WSCC Highways Consultation Response, HTp Response Note

ARUN DISTRICT COUNCIL P/140/16/OUT

WEST SUSSEX COUNTY COUNCIL **DATE: 27th January 2017**
STRATEGIC PLANNING CONSULTATION

SUBJECT: **P/140/16/OUT - Outline application for access only - mixed use development comprising of up to 400 dwellings, a care home with up to 70 beds, a Local Centre comprising up to 2000sqm of A1/A2/A3/D1/sui generis floorspace, provision of land for a 1FE primary school (with sufficient space to ensure that it is expandable to 2FE), provision of land for a scout hut, safeguarding of land to help link the site to the Pagham Harbour Cycle Route & other community uses including public open space & allotments with some matters reserved. This application is a departure from the Development plan**

Plans of the Proposed Site Access Junctions with Pagham Road

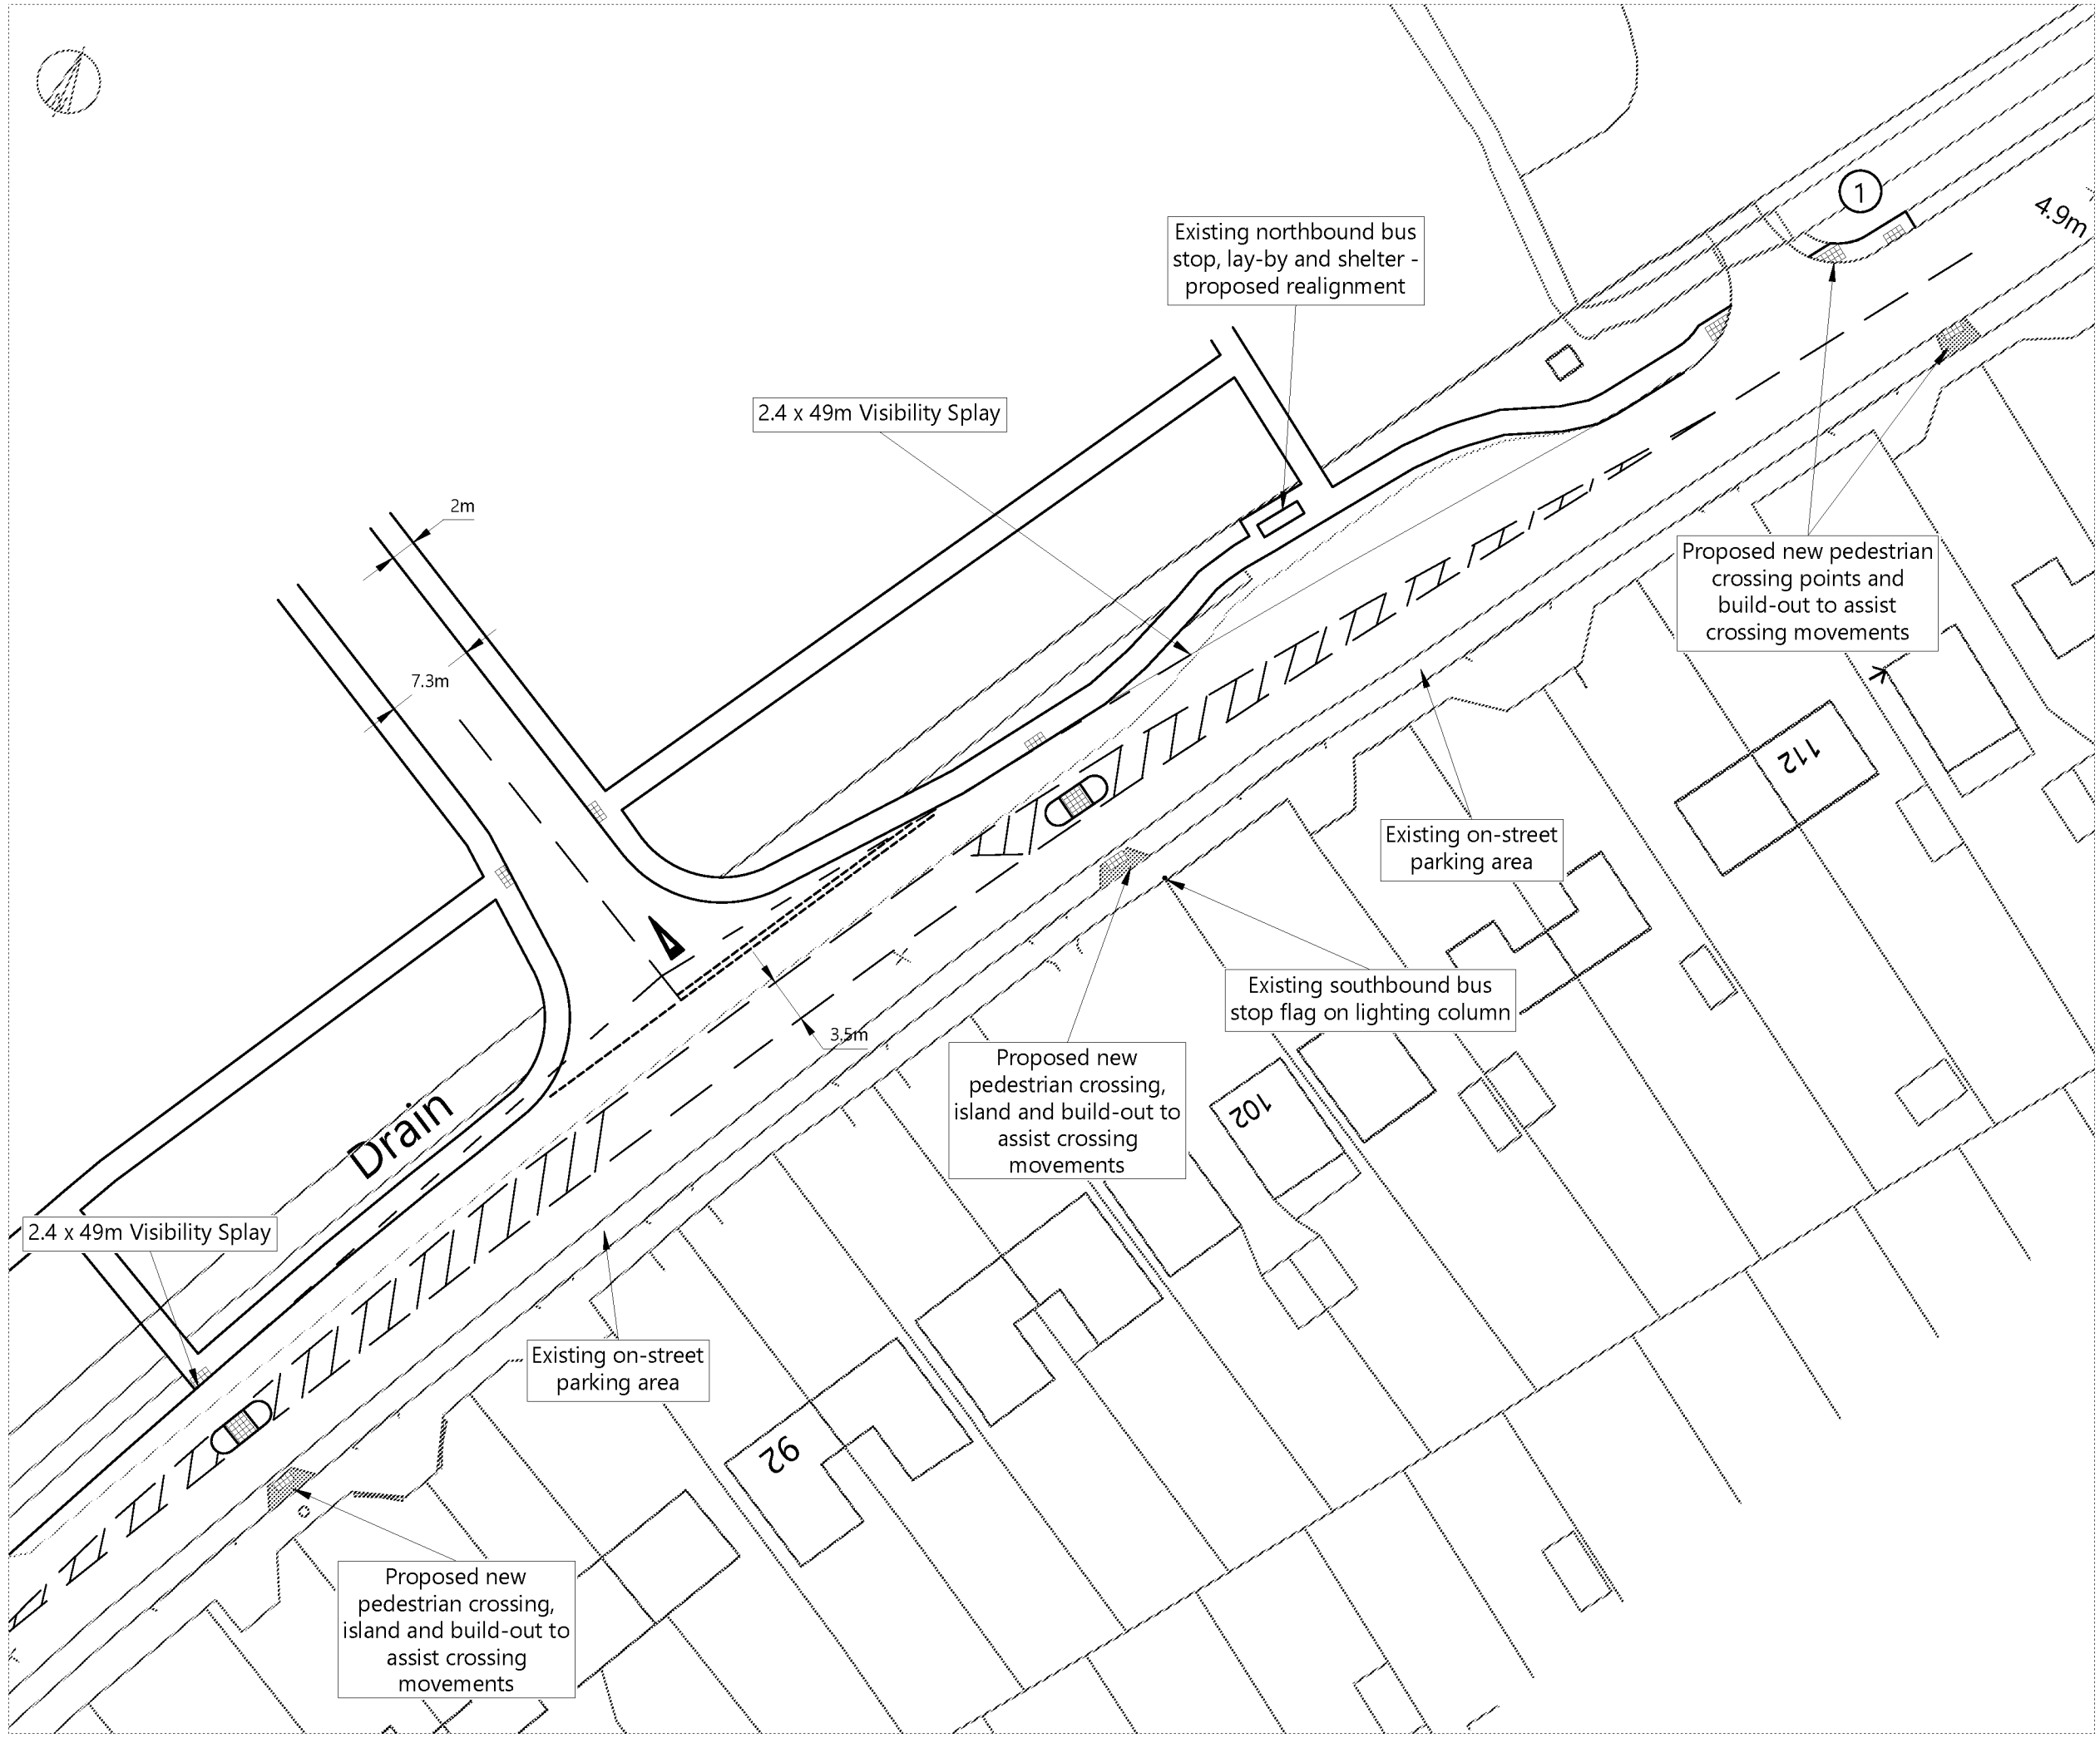
4. The site is to be served by two vehicle accesses onto Pagham Road, which in this location is subject to a 30mph speed limit. Both accesses take the form of priority junctions with right turning lanes. As part of pre application discussions, the applicant was informed that a formal design audit would be required. This should cover in detail what standards and guidance have been applied to the design of the accesses. No such audit has been submitted. This would be necessary.

6. In light of the posted speed limit and recorded vehicle speeds, the starting point for the design of the vehicular accesses should be Manual for Streets (MfS and MfS 2). MfS 2 provides further recommendations as to where and when right turning lanes should be used. This suggests that where traffic flows are low that junctions without right turn lanes will often be able to cater for higher levels of turning traffic without resulting in significant congestion. Whilst further comments are made below in terms of highway capacity, it is apparent from the summary capacity outputs that the two proposed accesses would operate well within capacity with very little queuing or delays on the major or minor arms. On this basis, it is questioned whether the highway works (that is the provision of right turning lanes) as shown are necessary.

7. It is recommended that an access arrangement based on two simple priority junctions is assessed in terms of capacity (by undertaking a further PICADY model) and safety (by way of a Stage One Road Safety Audit). Providing it can be demonstrated that simple priority junction would function acceptably, the LHA would be supportive of the right turning lanes being removed.

8. Stopping sight distances/visibility from the proposed access points have been based on the wet weather 85th percentile vehicle speeds rather than the posted speed limit. The use of 85th percentile speeds is an accepted means of determining SSD's for existing roads rather than using the posted speed limit.

9. The results of the speed survey are included. It's unclear exactly where the survey was undertaken. This is especially relevant given that distance between the two accesses, and therefore whether speeds recorded in one location are relevant to another. Irrespective of this, significantly greater SSDs than the 49 metres shown can be achieved at the northern access. At the southern access, the alignment of the existing carriageway restricts visibility to the north, although a distance of 90 metres is still achievable. The SSDs at both access points are achievable entirely within the public highway and/or land under the control of the applicant. It is accepted that adequate visibility can be achieved onto Pagham Road from both accesses.

10. For pedestrians, a number of 1.5 metre wide uncontrolled refuge islands are proposed along Pagham Road. 1.5 metre wide refuges would be quite narrow and would not be of sufficient width to allow a person pushing a buggy to wait in the centre of the carriageway. 2 metre wide refuges should be provided. Buildouts would also be necessary within the parking lay-by on the west side of Pagham Road to ensure that pedestrians are not crossing between parked vehicles.

It was discussed with the highway officer that a recommendation for refusal would not be placed on the application, however WSCC officers would prefer to not have a ghost right turn lane on the southern access. It has been agreed that this can be removed, but that the pedestrian refuge islands are to remain to facilitate pedestrian crossing movements. Therefore revised drawing HTp/1616/02/H issued to WSCC on 10/02/17, agreed as acceptable subject to receipt of Design Audit.

Survey locations issued to the highway officer on 31/01/17 and included in TA/01/A. It was agreed that the 90m visibility (DMRB measurement) can be achieved from both site accesses to either direction, and a visibility splay plan was issued (HTp/1616/10) demonstrating that even with a bus parked in the bus layby adjacent to the northern access, a 90m visibility splay can still be achieved.

Revised drawings (HTp/1616/01/G and HTp/1616/02/G) issued to the highway officer on 31/01/17 with 2.0m wide pedestrian refuges and highlighting build-outs within the on-street parking areas to assist pedestrian crossing movements; agreed with the highway officer as acceptable and included in TA/01/A.

Swept Path Analysis of Site Access Junctions

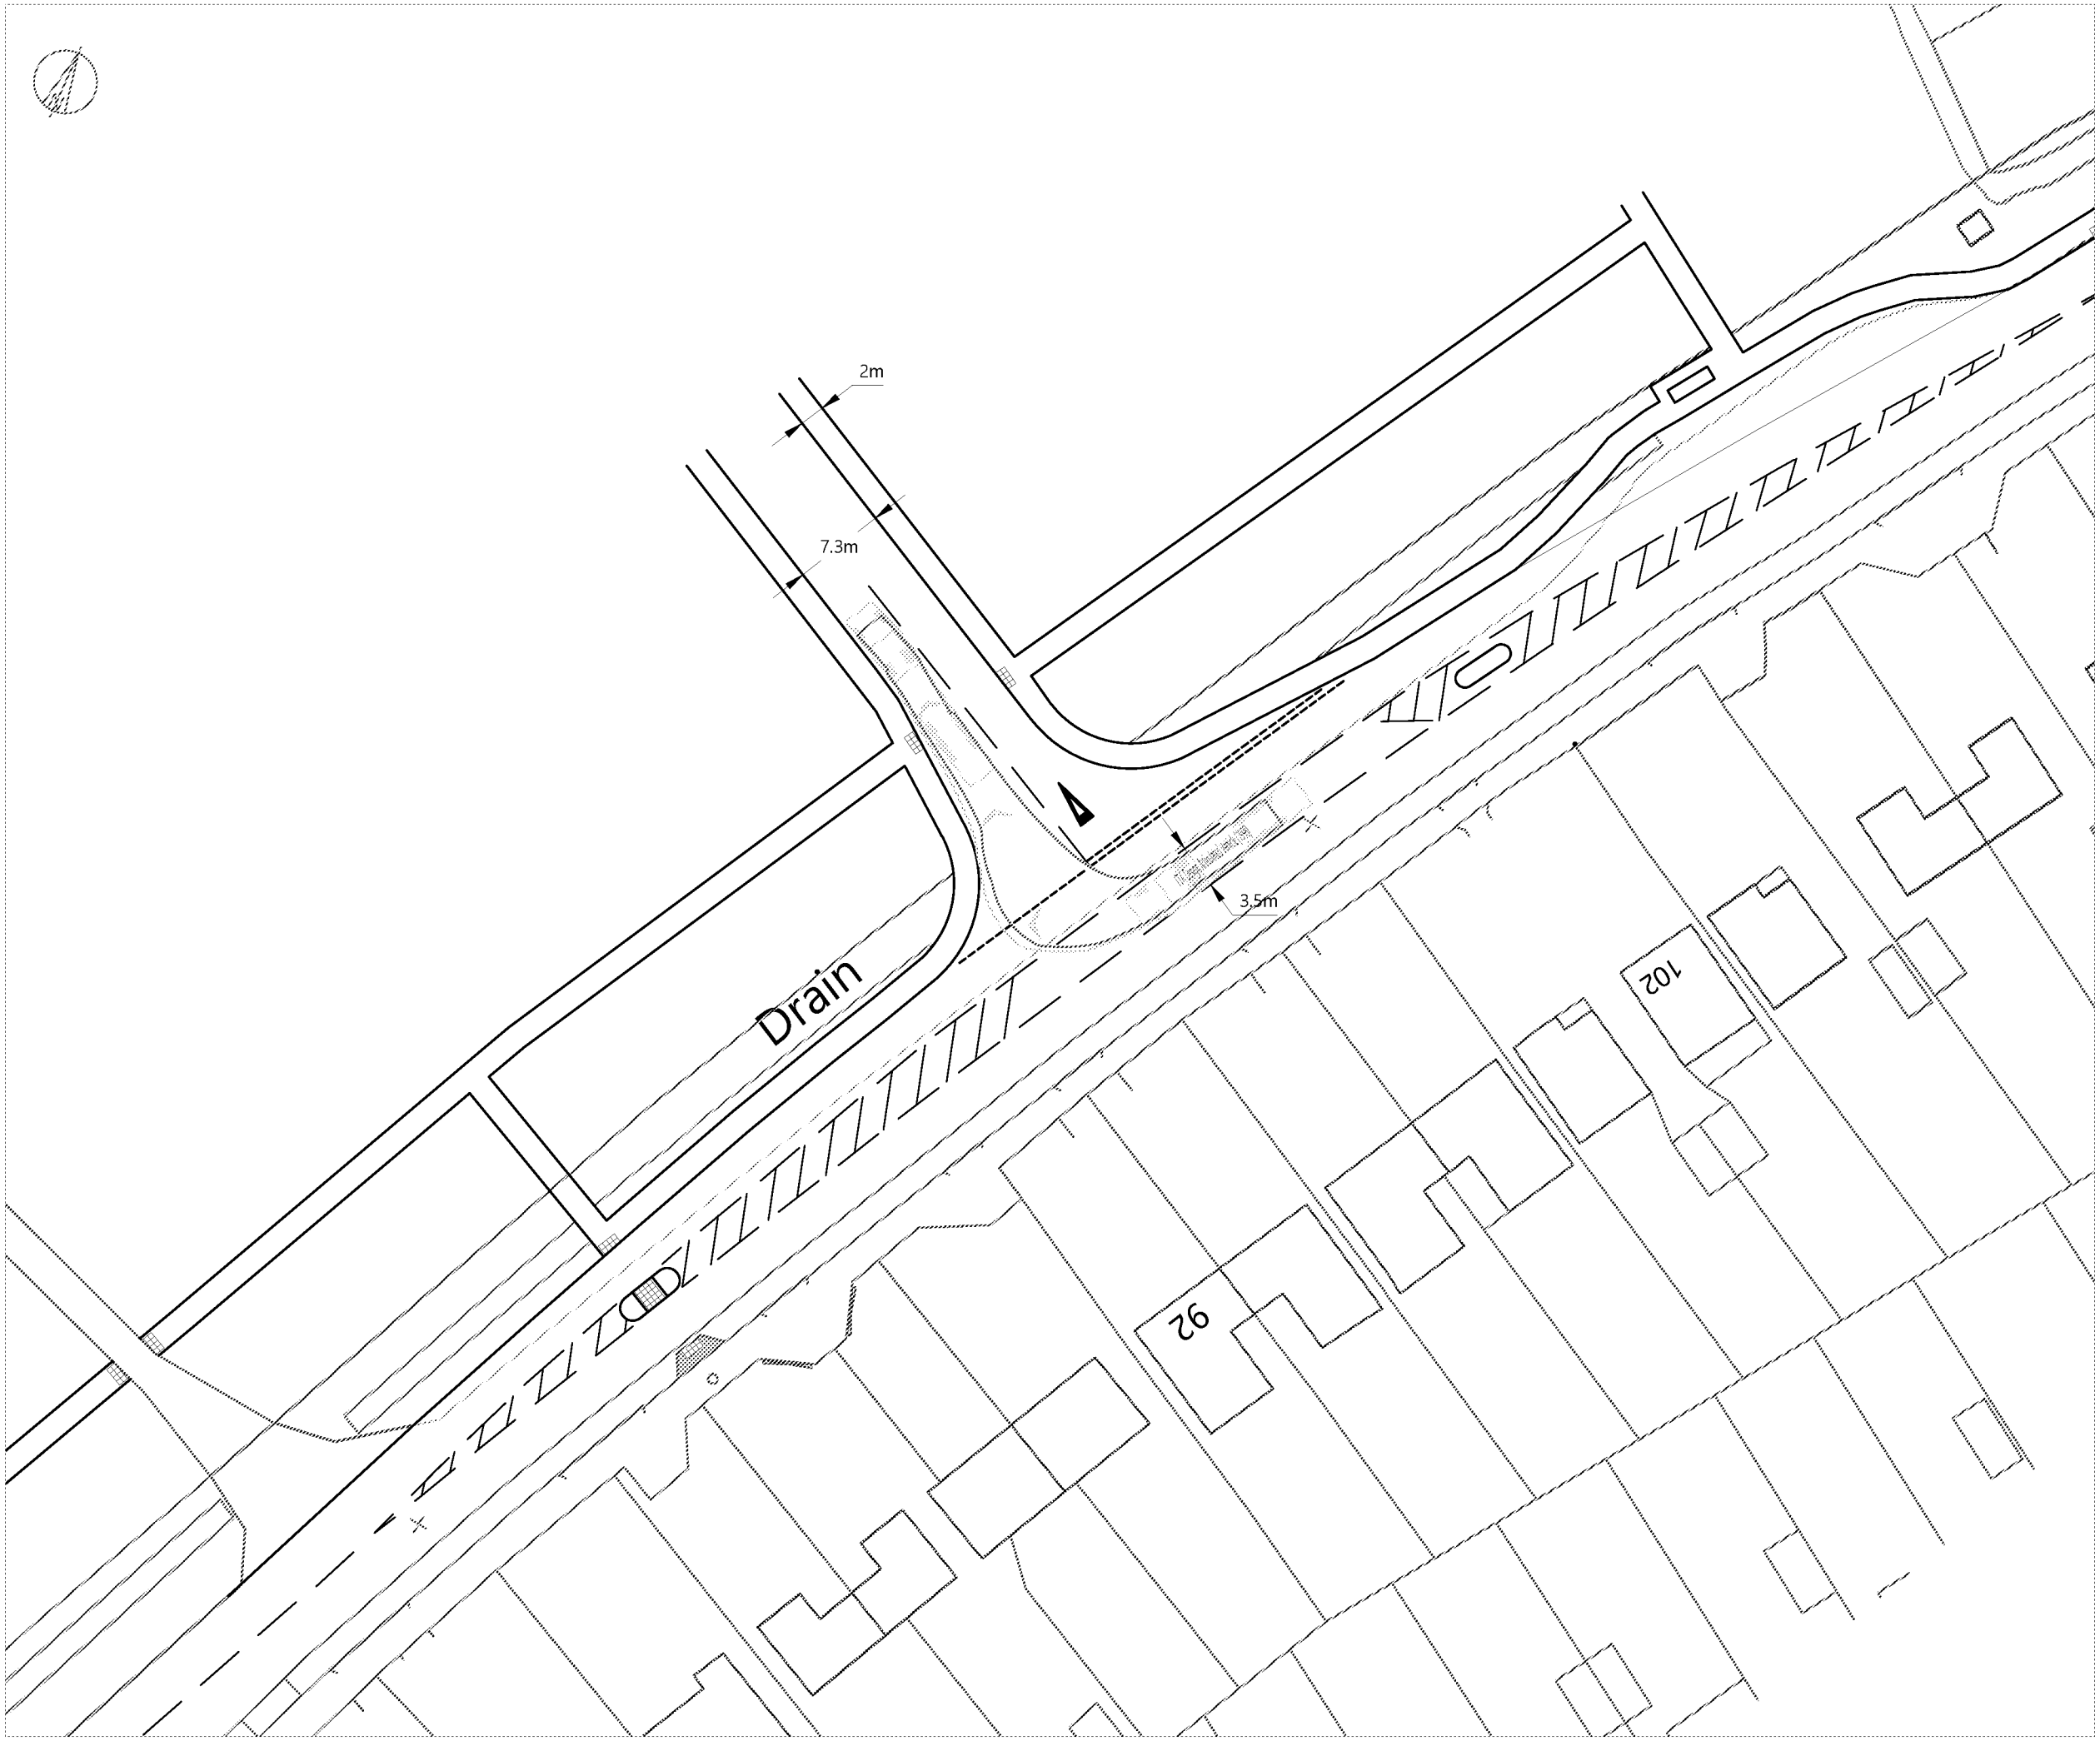
ii. RSA1 – point 2.1.1
A swept path analysis indicating a bus pulling into, stationary within, and pulling out of the proposed relocated bus stop was contained in Appendix 17, and is attached to this email as a standalone plan for ease of reference. Please can you confirm that it is acceptable? Many thanks.

The access arrangements have been the subject of a Stage One Road Safety Audit. The majority of problems have been positively resolved. There are several problems that require further comment.
2.1.1 – The bus stop lay-by is understood to be the same dimensions as that already present. Providing it is demonstrated that a bus can stop entirely within this, the dimensions are accepted.
